**Wellington City Council
Proposed District Plan
Hearing Stream 5**

Submission to Hearings Commissioners

Name: Survey & Spatial New Zealand (Wellington Branch)
Submitter #439 and Further Submitter #FS116

Figure 1: Comparison of PDP and ODP definitions of “cut height”

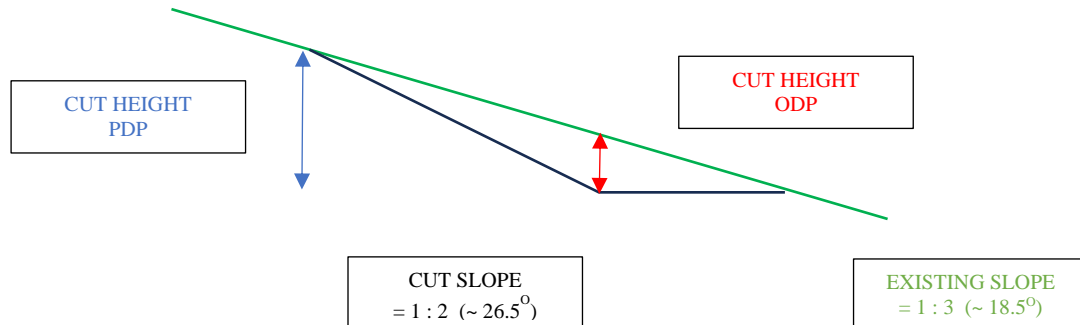
We sought that the definition of cut height should be amended to measure the vertical change in height of the excavation. That is, the vertical distance between the existing ground surface and the excavated surface.

The notified definition would measure the apparent height of a cut batter slope.

As shown in the diagram below, the proposed definition leads to a greater measurement of the cut height, which will result in a lot more earthworks proposals requiring resource consent.

We consider that the proposed definition of Cut Height is inconsistent with the intentions of the Section 32 report and therefore should be changed as per our submission.
